University of Western Sydney
Parramatta Campus

Indigenous Centre of Excellence

Sydney, 18th February, 2025
Ref. No. 237139-co-E02

Utility Services Response to Submissions

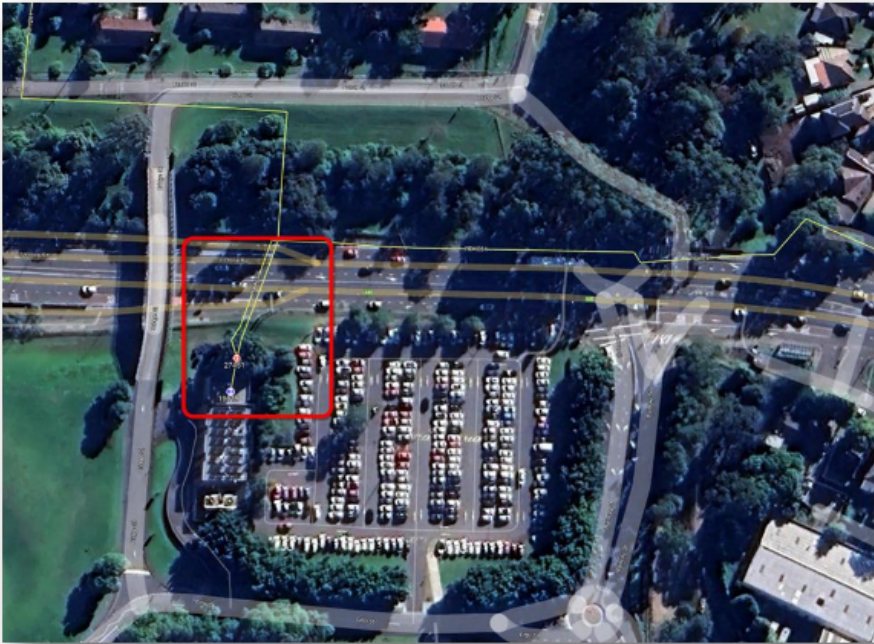
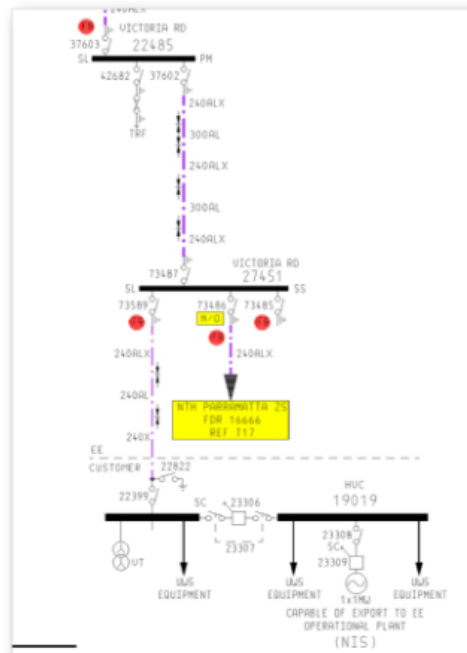
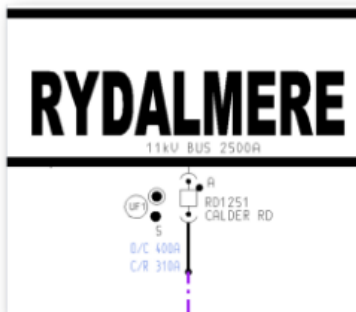
Endeavour Energy - The electricity distribution network relies in part on the retention of appropriate building setbacks to the road frontages to allow for line route / network design options and to provide safety clearances to conductors. Particular regard needs to be had to secondary road frontages or where overhead power lines are located near side or rear boundaries where lesser building setbacks apply. The higher the voltage, the greater the safety clearance required. This is also in keeping with a policy of prudent avoidance.

As a guide, Endeavour Energy's Mains Design Instruction MDI 0044 'Easements and Property Tenure Rights', Table 1 - 'Minimum easement widths', requires a minimum easement width of 9 metres for low voltage up to 22,000 volt / 22 kilovolt (kV) high voltage overhead power lines ie. 4.5 metres to both sides of the centreline of the poles / conductors. For higher voltages, the wider the required minimum easement width.

The EIS indicates 'Boundary Setbacks Northern: 2.83m' being to the Victoria Road frontage where there are low voltage overhead power lines.

The existing Endeavour Energy aerial cabling is outside of the site boundary. Contractor to maintain authority safety clearances.

SV do not have any details of the existing aerial cabling on the UWS side of Victoria Road.

SV only have the below information from Endeavour Energy which indicates the 11kV cabling is located on the opposite side of the road.

SV have undertaken a review on Google Earth and the aerial cabling between the power poles on the UWS side of Victoria Road adjacent the site appear to be either 230V or 415Volt aerial cabling, however, this would need to be confirmed by Endeavour Energy.

AS/NZS 3000 defines low voltage cabling as exceeding 120Vac but not exceeding 1,000 Vac, therefore, the 9m easement (cantered on aerial cabling) would still apply.
